Our Case Number: ABP-316272-23

Re: Bus Connects Templeogue/Rathfarnham to City Centre Core Bus Corridor Scheme
Templeogue/Rathfarnham to City Centre

BUSCONNECTS TEMPLEOGUE/RATHFARNHAM CORE BUS CORRIDOR SCHEME

Bushy Park Quiet Neighbourhood

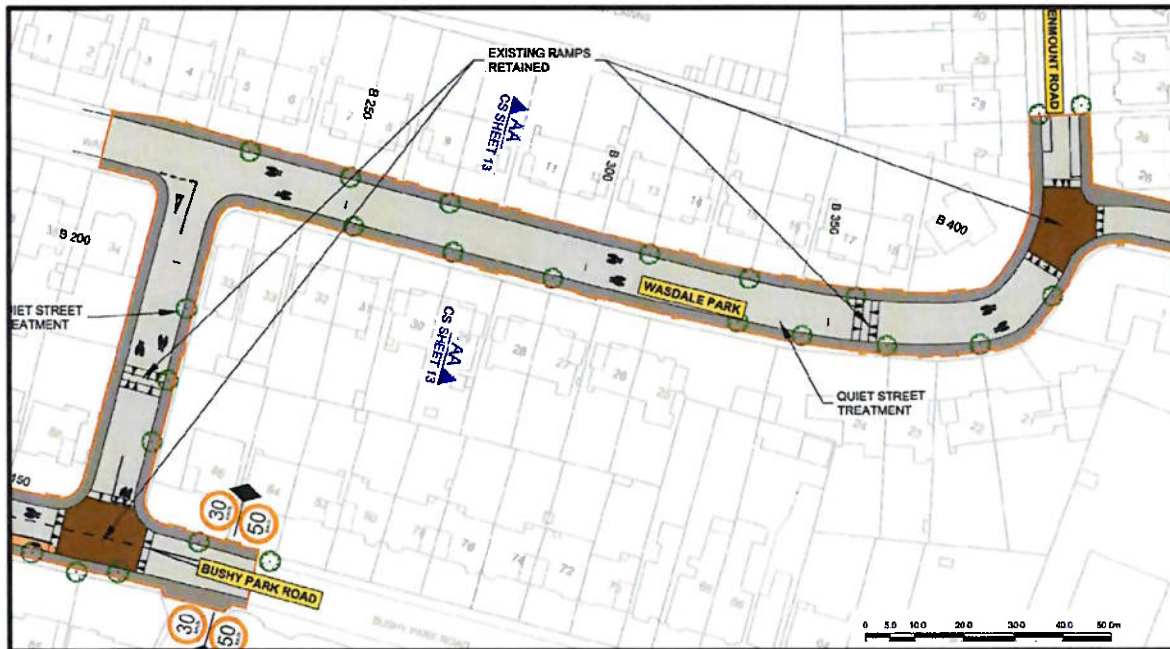
There is a risk that vehicles will not adhere to the 30kph speed limit. We would request the installation of chicanes and other traffic calming on this section to slow down vehicles, reduce rat-running and create the environment needed for a safe quiet street detour.

Templeogue Road/Old Bridge Road

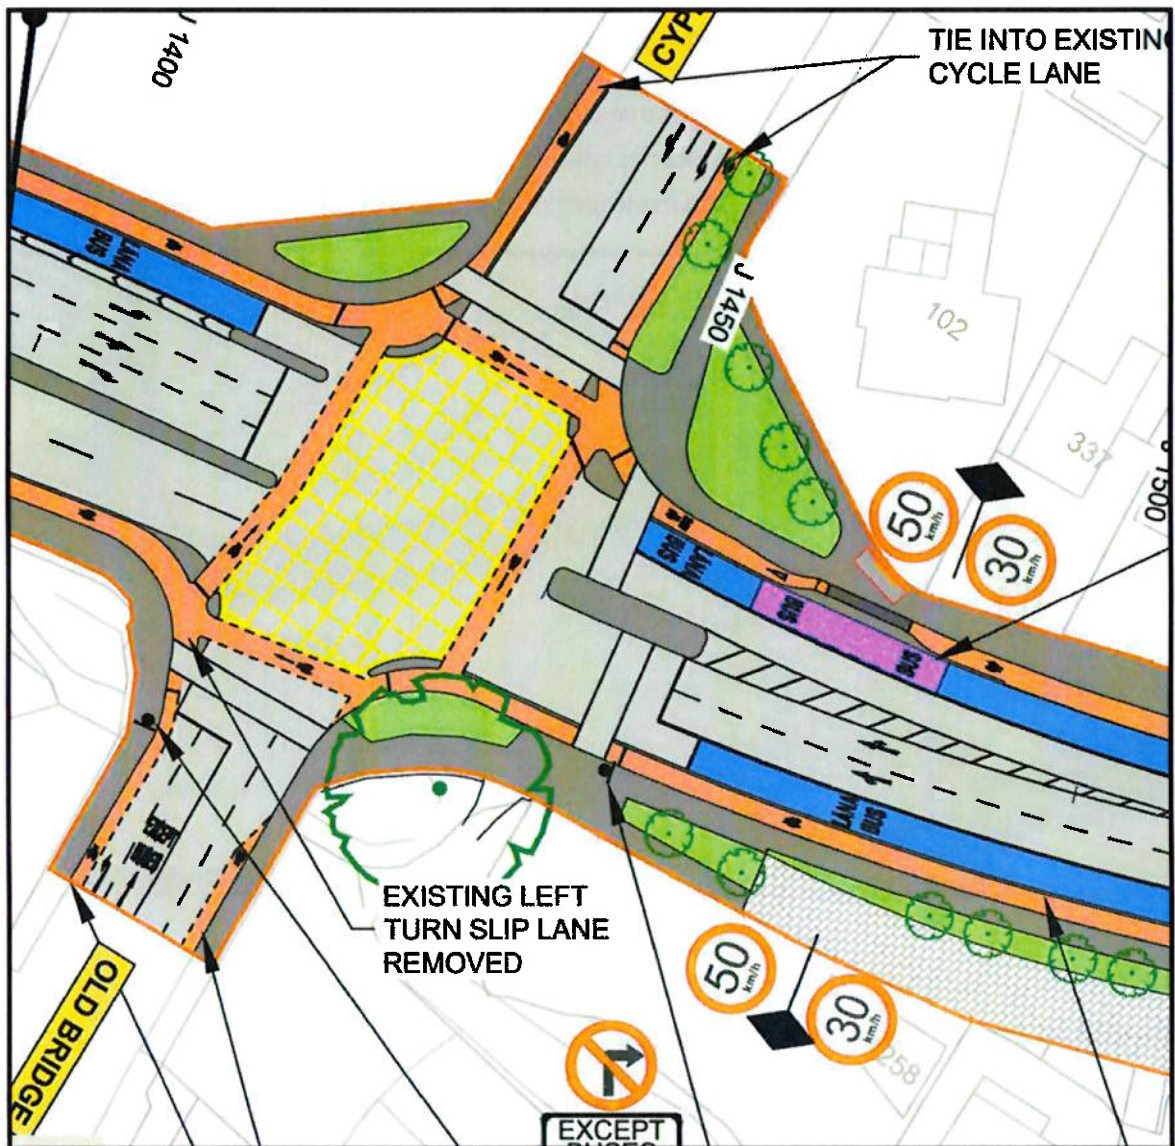
The absence of crossings on all arms of this major junction (sheet 32/42) is a significant oversight that should be corrected. We insist on installing a pedestrian crossing to ensure people can cross safely across six lanes of traffic. As it's designed, a pedestrian on the North-west corner would need to wait at four light sequences to get to the South-west junction and have potential conflict with cyclists at five separate points.
